ENGINEERING RECORD DRAWINGS

WALDEN PRESERVE 2
Filing No. 4
Construction Drawings
El Paso County, Colorado

WALDEN PRESERVE 2
Filing No. 4
Grading & Erosion Control Plans
El Paso County, Colorado

RESTRICTOR PLATE DETAIL E2

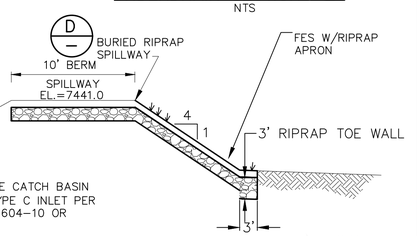
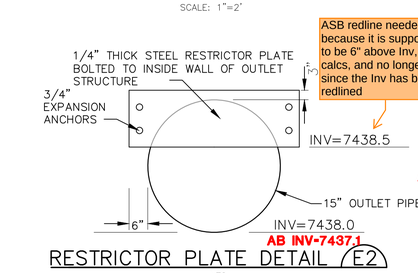
Top of box only 0.08ft above the pond bottom. See my comment in the as-built MHFD-Det calcs regarding this.

ASB redline needed because it is supposed to be 6" above Inv, per calcs, and no longer is since the Inv has been redlined
